## Meeting Notes

### Project 2007-06 System Protection Coordination Standard Drafting Team

January 22-24, 2013

**Process Flow Chart:** Below is a complete representation of the process, including the relationships between requirements:

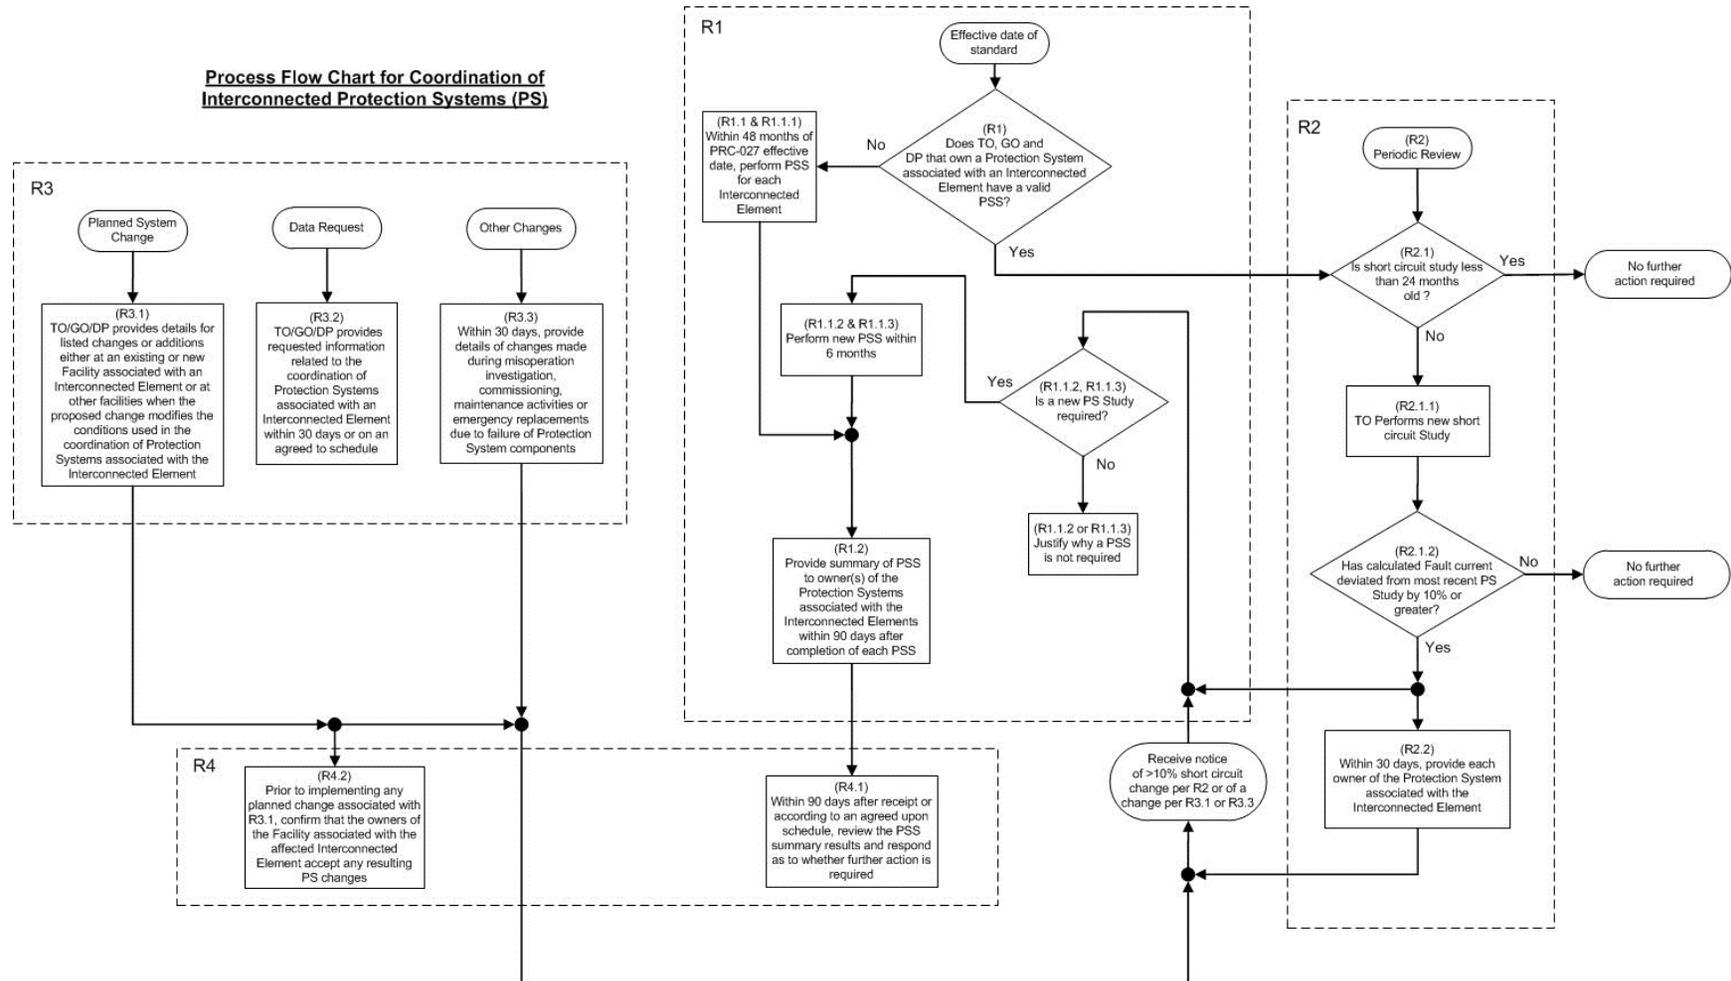
<p>Under 4.3.2 you have 30 days to confirm that the changes are acceptable. Under 1.1.3 you have to do a protection study so you are given 90 days per section 1.2. This entire chart should be verified to ensure that it matches the written standard and does not result in conflicting requirements. We suggest adding the sub-requirement labels to each flow chart item for easier reference to that section of the standard.</p> <ol style="list-style-type: none"> <li>In regard to Figure 3 on page 25 - The figure appears to represent the connection of a large NERC qualified generator. Does this figure also apply to a looped source distribution system or should that follow figure 4? We would like to see a definitive example that clarifies what to do for the situation where you have a looped source distribution system.</li> <li>In regard to Figure 4 on page 26 - the figure implies that A &amp; B can be set to overtrip C (as no study is required) which would interrupt the BES for distribution faults. This appears to be contrary to what is intended by this standard.</li> </ol>

<p><b>Response: Thank you for your comment.</b></p> <ol style="list-style-type: none"> <li>The drafting team is striving to improve the standard through the balloting process.</li> <li>The drafting team has modified the flowchart based on comments and to reflect all changes made to the standard.</li> <li>Figure 3 is represents a generator connected to a Distribution Provider. The drafting team modified Figure 3 to indicate that the source could be a generator or a network system. The Applicability Section 4.2 Facilities states: “Protection Systems installed for the purpose of detecting Faults on Interconnected Elements of the BES and that require coordination for isolating those faulted Elements”, which the team believes clarifies those Protection System Elements that are required to be coordinated under this standard. This does not include a Protection System that would operate for a Fault on the Transmission System, if that is not its primary purpose. Figure 4 is intended to be a radial Distribution System with no source.</li> <li>Figure 4 is intended to illustrate a situation where no Protection System Study is required per this standard because there is no Protection System installed to detect Faults on the BES Transmission System. This does not preclude the Transmission Owner from reviewing the Protection System to ensure the system operates as designed.</li> </ol>

**Figure 3**

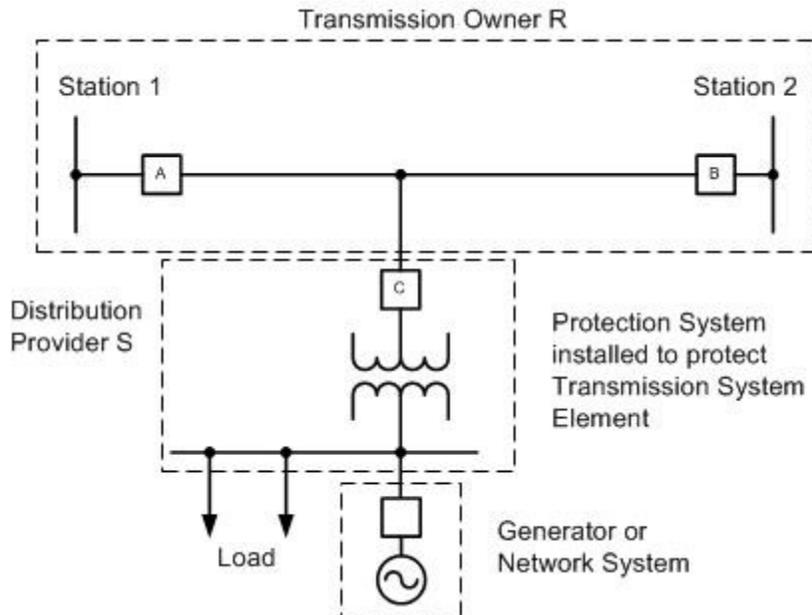
Numerous commenters wanted the description associated with Figure 3 clarified. The drafting team noted that: Figure 3 is independent of whether the facilities are part of the BES. The intent is to identify that the coordination is required where Protection Systems are installed for the purpose of protecting Transmission System Elements. The drafting team added a note of clarification of the phrase

Organization	Question 8 Comment
SERC RRO	<p>Please change Figures 3 and 4 so that "Interconnected Element" is adjacent or points to the line between Breaker C and the point of connection (tap point) on the line between Breakers A and B. It clarifies these examples by having the Figures align with your wording. (The Figures presently imply that the line between Breakers A and B is the "Interconnected Element".)The comments expressed herein represent a consensus of the views of the above-named members of the SERC EC Protection and Control Subcommittee only and should not be construed as the position of SERC Reliability Corporation, its board, or its officers.</p>
<p><b>Response: Thank you for your comment. The suggested change has been made to the figures [TWM3].</b></p>	
American Electric Power	<ol style="list-style-type: none"> <li>1. PRC-001-3: R1 "The term "protection system" should be capitalized to match previous versions of this standard.</li> <li>2. PRC-027-1: Mapping Document "The verbiage in R1.1 of the mapping document does not match the wording in the proposed standard: "Protection System Study" is used instead of "PSCS".</li> <li>3. PRC-027-1: Figure 2 "The phrase "generator Protection Systems" is often used by Generation Owner relay engineers to mean the Protection Systems installed for the purpose of detecting faults on and protecting the physical generator, which is clearly outside of the scope of this standard. Therefore, AEP recommends changing the verbiage associated with this figure to remove the phrase "generator Protection Systems" and replace it with a reference to Generator Owner R's Protection Systems installed for the purpose of detecting faults on the Interconnected Elements. Suggested wording is shown below: <ul style="list-style-type: none"> <li>Transmission Owner S is to review the Protection System settings associated with Breaker A *and the Interconnected Element* (provided by Owner R) for coordination issues with the Protection System settings associated with Breakers C, D, E, and F. Likewise, Owner S is to develop proposed Protection System settings associated with Breaker C. Generation Owner R is to review the Protection System settings associated with</li> </ul> </li> </ol>

The drafting team revised the description relating to Figure 3 in the “Guidelines and Technical Basis” to clarify that only the Distribution Provider’s Protection Systems installed to protect for Faults on Transmission System Elements are a part of the Applicability of this standard. The drafting team modified Figure 3 to indicate that the source could be a generator or a network system.

“Protection Systems installed to detect faults on the BES Transmission System.” Figure 3 represents a generator connected to a Distribution Provider. The drafting team revised the description relating to Figure 3 in the “Guidelines and Technical Basis” to clarify that only the Distribution Provider’s Protection Systems installed to protect for Faults on Transmission System Elements are a part of the Applicability of this standard. The drafting team modified Figure 3 to indicate that the source could be a generator or a network system.

**Figure 4**

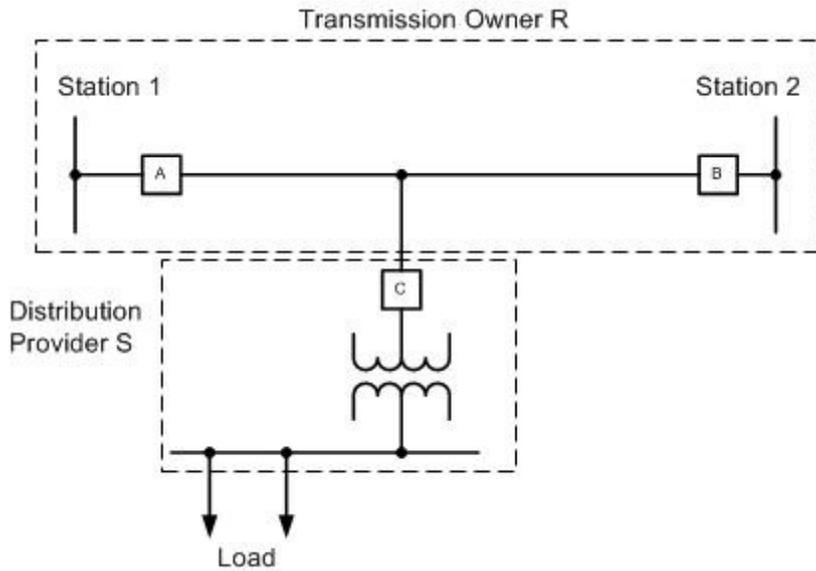
Organization	Yes or No	Question 2 Comment
		<p>purpose of detecting BES faults on Interconnected Elements. Therefore, in example Figure 4 the DP does not own ?facilities? and the transmission line or tap are not an Interconnected Element. The definition of Interconnected Element should reflect this fact and Figure 4 should be corrected. If the intention is that Figure 4 should be an Interconnected Element so that R2 still applies, then clarification that Interconnected Elements does not require Applicability section 4.2 defined facilities is required.</p> <p>2. ITC Holdings engineers perform coordination at Interconnected Elements between ITC Holdings subsidiaries ITCTransmission and METC, both registered TOs. The definition should exclude applications such as this, where the only outcome is increased administrative burden to be auditable with no reliability benefit to BES.</p>
<p><b>Response: Thank you for your comment.</b></p> <ol style="list-style-type: none"> <li>1. The drafting team revised <b>Figures 3</b> and 4 and the associated texts for clarity.</li> <li>2. The drafting team disagrees with your premise. The drafting team intends for this standard to address coordination of Protection Systems installed for the purpose of detecting Faults on Interconnecting Elements, and that require coordination for isolating those faulted Elements - between separate Registered Entities or between separate functional entities within the same Registered Entity. For the case where two registered entities with the same protection group are doing all the coordination, the drafting team included the following note: "In cases where a single group performs an overall coordination study for a given Interconnecting Element; a single document that provides the requirements for a summary of the results of the PSCS would be sufficient for use by all entities."</li> </ol>

Organization	Question 8 Comment
	<p>note may create unintended bias.</p> <p>6). Dominion agrees with SERC PCS comment: ?Please change Figures 3 and 4 in the Applications Guidelines section so that ?Interconnected Element? is adjacent or points to the line between Breaker C and the point of connection (tap point) on the line between Breakers A and B. It clarifies these examples by having the Figures align with your wording. (The Figures presently imply that the line between Breakers A and B is the ?Interconnected Element?.)</p>
<p><b>Response: Thank you for your comments.</b></p> <ol style="list-style-type: none"> <li>1) The drafting team used “present” to qualify the short circuit study and “most recent” to qualify the Protection System Coordination Study, which are two different studies. It is only when the difference between the values in the two types of studies exceeds 10% does a new Protection System Coordination Study need to be performed. No change made to the standard.</li> <li>2) The first bullet refers to any changes made to the Protection System(s) and the drafting team did not believe it was necessary to individually bullet each component, whereas the other bulleted items refer to different types of changes that could change the impedance in the system. No change made to the standard.</li> <li>3) The drafting team believes that the Note in the rationale box for Requirement R1 and the second bullet in the Example Process are consistent and are adequate and sufficient to eliminate confusion about what is required. No change made to the standard.</li> <li>4) <b>The drafting team has changed the Applicability section to remove the separate 4.2.1.</b></li> <li>5) The drafting team recognizes that engineering judgment will be used by entities to perform a PSCS. However, it believes that the language of the standard is accurate and appropriate. Since at least two entities will be performing or reviewing the PSCS, the drafting team believes that the appropriate system configuration will be used in modeling the system for the PSCS. There is no way to measure whether entities have determined “the best scenario under which to evaluate coordination.” No change made to the standard.</li> <li>6) <b>The suggested change has been made to the figures.</b></li> </ol>

<p>Duke Energy</p>	<ol style="list-style-type: none"> <li>In the interest of clarity, Duke Energy feels an example of acceptable evidence for measure 3 of PRC-027-1 R2 would be beneficial.</li> <li>In PRC-027-1, Duke Energy identified a potential gap in Figure 4 of the Application Guidelines. Duke Energy believes that without coordination between the DP and TO, it could lead Transmission Planners and System Protection Engineers to disregard the coordination with protection for the tap line between BES and non-BES equipment. Given the proposed definition of the BES, this scenario could potentially pose a risk to the BES without the proper coordination identified in PRC-027-1.</li> </ol>
<p><b>Response: Thank you for your comment.</b></p> <ol style="list-style-type: none"> <li>The drafting team believes the example given – “engineering analyses or assessments” – provides entities the ability to apply their own engineering expertise and practice in documenting a technical reason why changes in fault current, based upon the entity’s own scheme design and/or application, do not affect the coordination of the Protection Systems involved.</li> <li>The drafting team has revised the figure to provide additional clarity that the Distribution Provider S depicted in Figure 4</li> </ol>

Organization	Yes or No	Question 9 Comment
<p>Therefore, a Protection System Study would not be required. .</p> <p>3. The drafting team believes the transformers in Figures 3 and 4 are not BES Elements.</p> <p>4. Based on your comment, the drafting team has added a note to the text of Figure 3.</p>		
<p>Ingleside Cogeneration LP, (Occidental Chemical Corporation)</p>		<p>It would seem that M9 should be reworded slightly so that it is clear that the compliance burden is placed on the party sending the confirmation. It seems like it should read “demonstrating the confirmation was sent within the respective time frames” instead of “demonstrating the confirmation was achieved within the respective time frames.” In other words, Requirement 4 compliance is solely for the confirming party to show evidence, not the submitting party.</p>
<p><b>Response: Thank you for your comment.</b></p> <p><b>Based on comments, the drafting team revised Measure M9 to read: “Acceptable evidence for R4, Part 4.1 is dated documentation (hardcopy or electronic file formats) demonstrating that response was provided according to the agreed-upon schedule, or within 90 calendar days absent such an agreement.”</b></p>

**Figure 5**

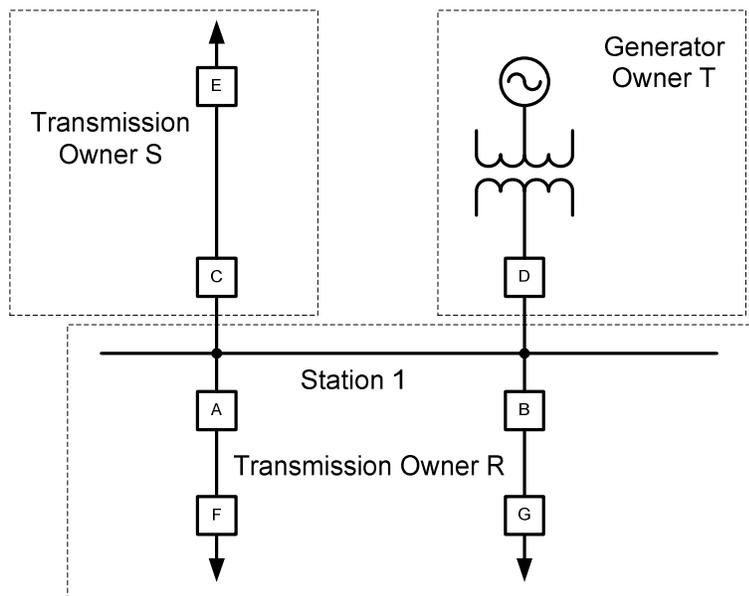
Organization	Yes or No	Question 9 Comment
		<p>"R" and TO "S" could be the same corporate entity). Figure 5 implies the letters "R", "S", and "T" refers to different corporate entities since there is a Transmission Owner R and a Transmission Owner S along with a Generator Owner T. If these letters do not indicate different corporate entities, then is it the intention of the SDT that all GO and DP facilities that connect directly to the BES be treated as "Interconnected Facilities"?.</p> <p>2) Additional clarification in the Application Guide (figure 3) is required as it would imply that proof is require that generation on a tapped substation does not pose a risk to the transmission system.</p> <p>3) The dates and documentation requirements for this standard will require an equivalently complex system or database for tracking in order to prove compliance. From review of the standard it appears that tracking of ~8 dates and associated supporting documents will be required for each interconnection study. Additional implementation time should be included in the standard for proper processes and tools to be in place prior to perform study or re-study work.</p> <p>4) Most study work would be initiated by R3.2 and typically involve multiple data requests for varying items and with associated responses providing the information. If each email request needs a corresponding response, then much time will be required to match emails topic for topic to meet this measure. The result will be multiple of same measure for study work, increasing tracking time for engineering. (i.e. more tracking time and less engineering time per engineering FTE). If the measure is to be based on first request to last response then this would easier to implement.</p> <p>5) As existing studies will fall under the measures of this document, with no grandfathering, it is likely existing studies will need to be re-evaluated. As a result, consulting services for competent protection engineering services may become limited and may impact the ability in meeting the 36 month requirement.</p> <p>6) Larger regional studies with interconnection impacts may be the outcome of</p>

Organization	Question 8 Comment
	<p>Breaker C *and the Interconnected Element* (provided by Owner S) for coordination issues with the Protection System settings associated with Breaker A.</p> <p>4. PRC-027-1: R3 &amp; Figure 5 ? As written, R3 will place undue burden on each TO, GO and DP to maintain a list of all other entities connected to each interconnecting bus to which they connect. Furthermore, since the elements are typically owned by the TO, burden will be placed on the TO to respond to requests from other TO?s, GO?s and DP?s as they build their list. R3 and its? associated Figure 5 should be revised such that the responsibility lies with the owner of the Interconnected Element to ensure that relevant information is passed along to each entity who connects to the element when any one entity makes a change.</p>
<p><b>Response: Thank you for your comment.</b></p> <ol style="list-style-type: none"> <li>1. <b>PRC-001 comment</b></li> <li>2. <b>The drafting team has made the suggested revision to the mapping document.</b></li> <li>3. <b>May be a valid observation. Team discussion.</b></li> <li>4. <b>The drafting team believes that entities making changes or additions to Protection Systems associated with an Interconnected Element must communicate the proposed changes to the other entities that will be affected by the change if systems are to be properly coordinated (R3), and that they must know who those entities are in order to provide such necessary communication.</b></li> </ol>
